Addendum 52: Regulation No. 53

Revision 2 – Amendment 3

Supplement 11 to the 01 series of amendments - Date of entry into force: 9 December 2010

Uniform provisions concerning the approval of category L₃ vehicles with regard to the installation of lighting and light-signalling devices

"Annex 6

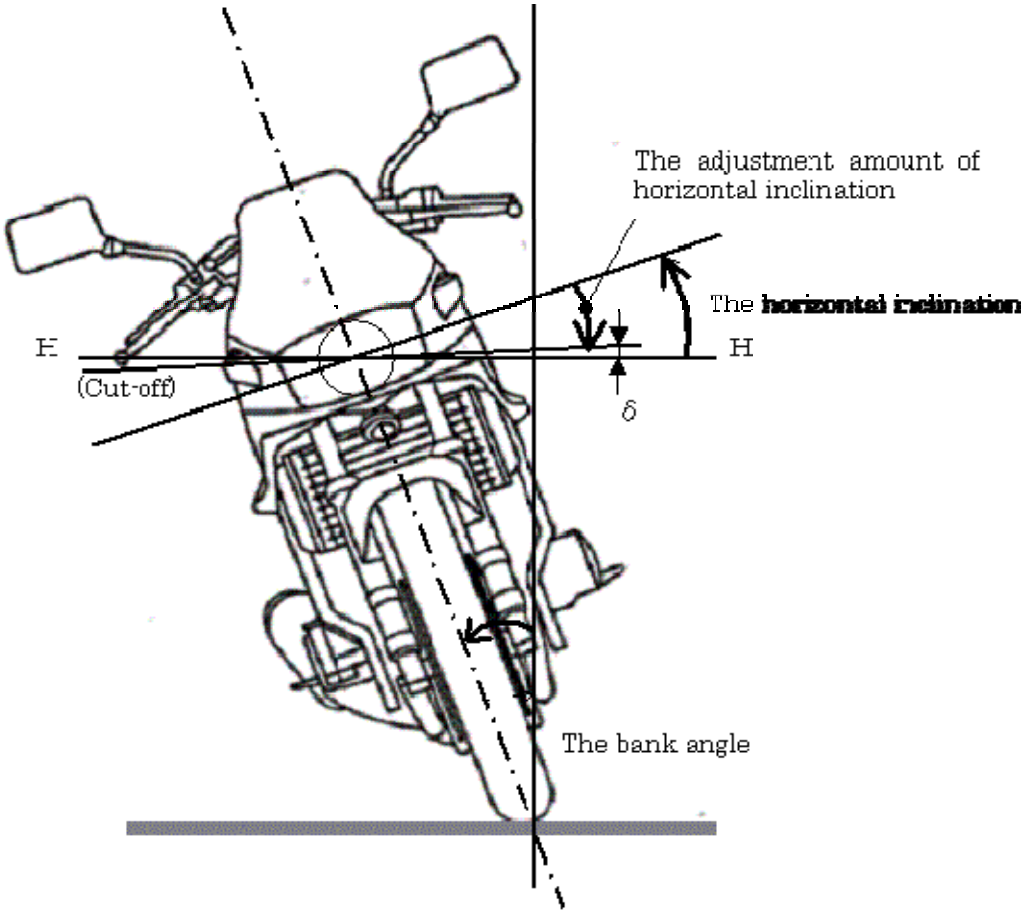
Insert a new Annex 6, to read:

Explanation about "the horizontal inclination", "the bank angle" and the angle " δ ".

Note: This figure shows the motorcycle is banked to the right side."

- "2.24. "Horizontal inclination" means the angle created between the beam pattern when the motorcycle is set as specified in paragraph 5.4., and the beam pattern when the motorcycle is banked (see drawing in Annex 6);

- 2.25. "Horizontal inclination adjustment system (HIAS)" means a device that adjusts the horizontal inclination of the headlamp towards zero;
- 2.26. "Bank angle" means: the angle made with the vertical by the vertical longitudinal median plane of the motorcycle, when the motorcycle is rotated about its longitudinal axis (see drawing in Annex 6);

- 2.29. "HIAS test angle" means the angle δ created by the headlamp cut-off line and HH line (in case of an asymmetrical beam headlamp, the horizontal part of the cut-off shall be used), (see drawing in Annex 6)."
